Minto Logistics Hub Modification 2

Changes to Stage 1 Warehouse
State Significant Development Modification Assessment
(SSD-7500-Mod-2)

March 2022

Published by the NSW Department of Planning and Environment

Figure 5 | Location of key works sought to be modified under this modification

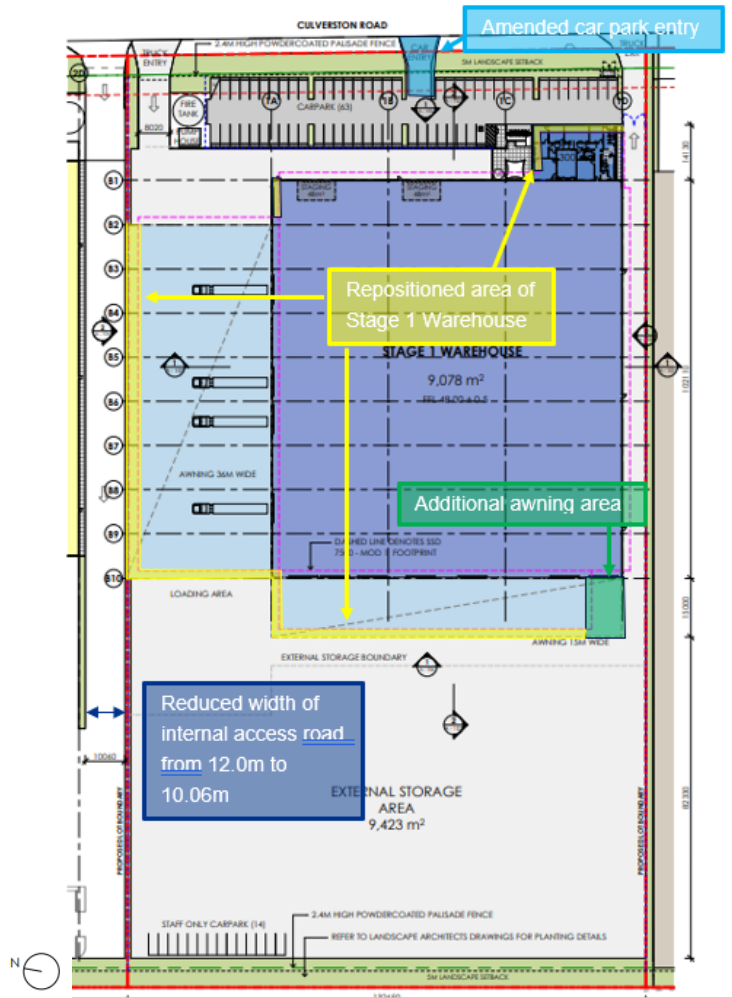
- amend the Stage 1 warehouse roof pitch from 2.5 to 3 degrees
- relocation of Stage 1 warehouse northwards by 1.94 metres (m) and westwards by 2.0 m
- relocation of Stage 1 warehouse office eastwards by 2.0 m
- repositioning of loading dock roller shutter doors on the Stage 1 warehouse northern and western elevations
- extension of the Stage 1 Warehouse western awning to the south by 9.6 m
- relocation of the car park access point from Culverston Road north by 41.95 m
- relocation of the retaining wall to the car park westwards by 0.5 m
- reduction in the width of the southern vehicle internal access road servicing the Stage 2 warehouse by 1.94 m to accommodate the amended boundaries (reduced from 12.0 m to 10.06 m)
- inter-tenancy boundary fence materials amended to be constructed of cyclone fencing
- align the staging boundaries with the amended tenancy boundaries.

Figure 6 | Proposed eastern elevation (top figure) compared to approved eastern elevation (lower figure) via Culverston Rd.

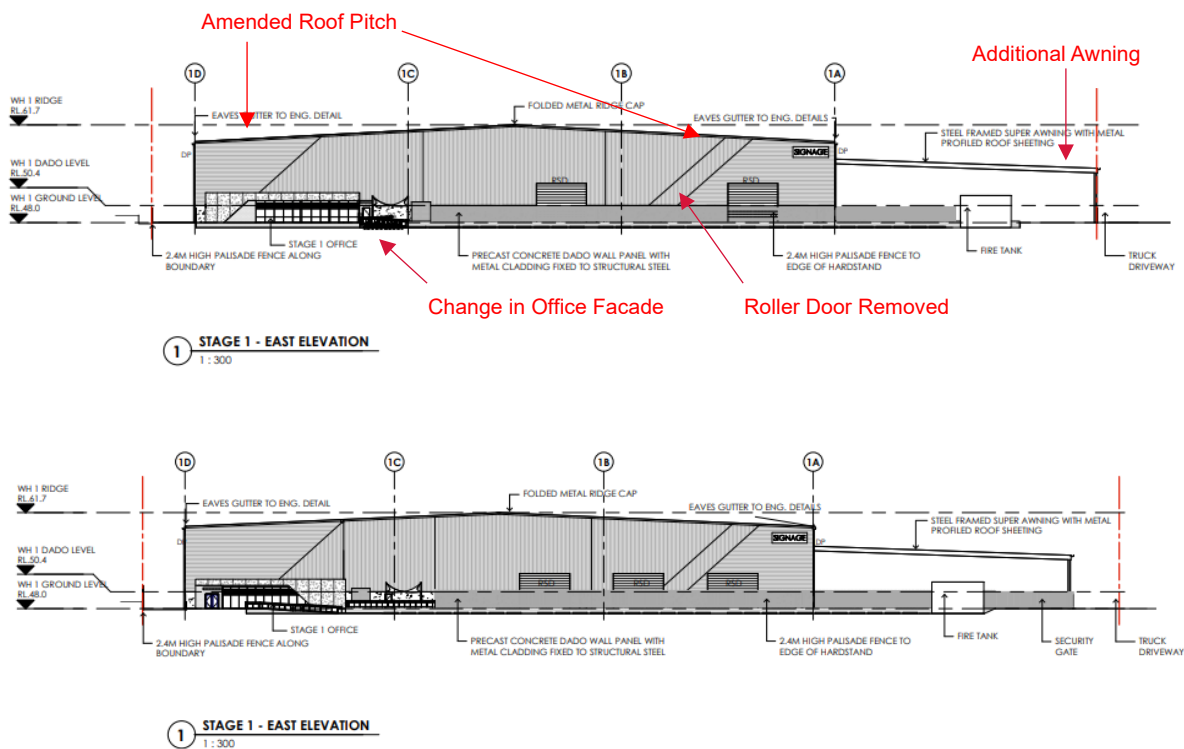
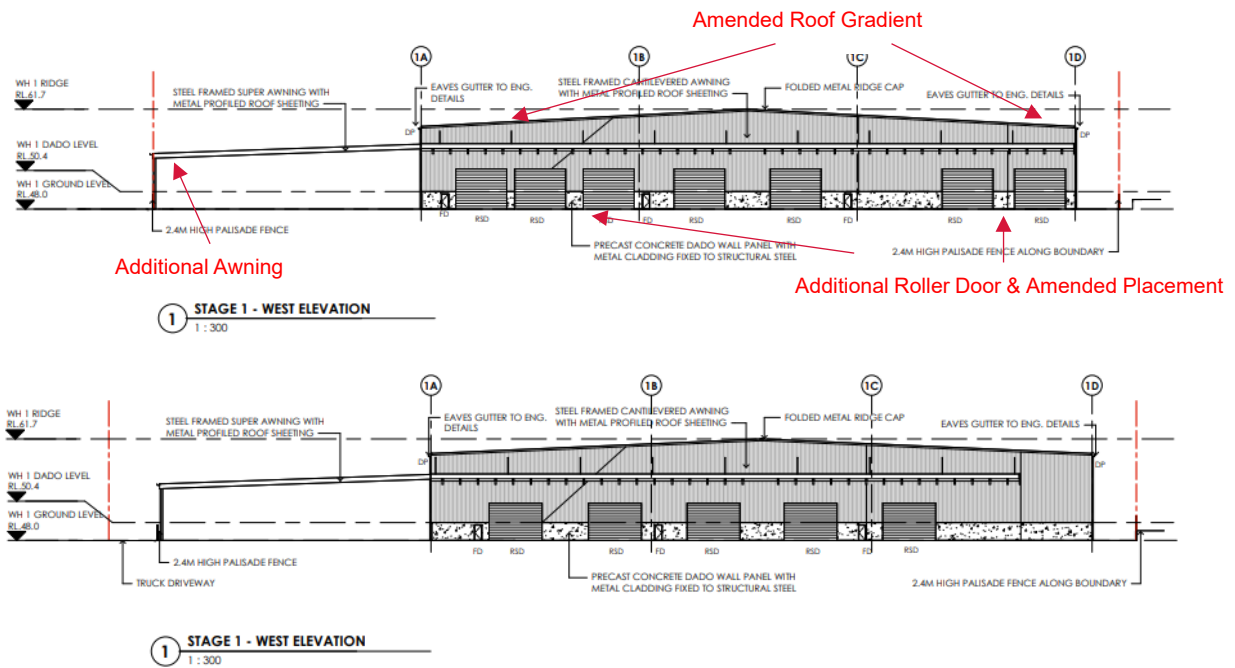
The visual impact of the proposal could also be altered by the amended roof pitch of the Stage 1 warehouse from 2.5 degrees to 3 degrees, the increase in the western elevation awning, and the amended car park entry.

To assess visual impact from the minor amendments, the Applicant supplied a Visual Impact Assessment (VIA) Addendum as part of its Modification Report. The VIA Addendum assessed the impact the amended footprint, additional awning and amended car parking entry would have from key vantage points, including from Airds Road. The Addendum compared the views from the listed vantage points and concluded the magnitude of the proposed changes would be negligible, even from Viewpoint 2 which is most impacted due to the proximity to the Stage 1 warehouse.

The Department agrees with the VIA Addendum conclusion, with little visual difference between the approved development and the modified design (see Figure 6 and Figure 7).

The Department’s assessment concludes the proposed siting and overall building bulk of the development is considered to achieve a commensurate scale in line with the visual impact considered in the original assessment and can be managed through existing conditions of consent.

Figure 8 | One-directional access driveway from the southern access with all exit movements undertaken from the northern egress driveway.

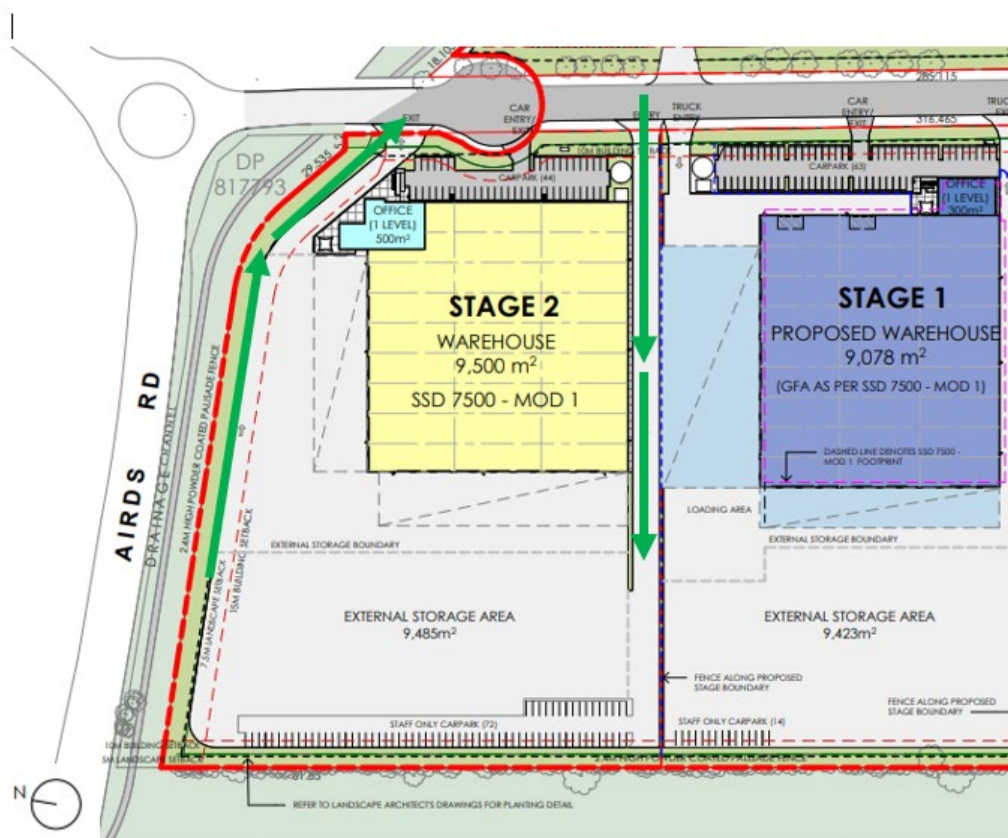
The reduction in the width of the Stage 2 warehouse internal road access from 12.0 m to 10.06 m removes the ability to provide for bi-directional traffic movement. This reduction reduces the capability of a truck entering from Culverston Road to pass a stationary car exiting from the same internal road. However, the Applicant proposes amendment to the access arrangement whereby the internal access road sited between Stages 1 and 2 (southern access) is to now be a one-directional access driveway for trucks and cars, with all exit movements to be undertaken via the Stage 2 northern egress driveway (see Figure 8).

Council has reviewed the proposal and did not raise any objections to the amendment to the traffic access arrangement subject to conditions addressing the new vehicle movement within the site.

The Department finds that the amendment to the bi-directional arrangement for southern Stage 2 warehouse access road will improve traffic movement for the site by removing potential truck and car conflict within this access road. Access to the approved secondary car parking along the western boundary is maintained, with continued sufficient access and manoeuvrability for a 26 m B-double vehicle to perform the required operations. All vehicle exit movements will be via the Stage 2 northern egress driveway in line with the original consent.

The Department's assessment concludes the proposed works will improve the existing traffic arrangements on-site and will have negligible impacts along the local road network during operation. The amendment to the Stage 2 access and egress can be adequately managed through conditions of consent in line with the original approval, as modified.
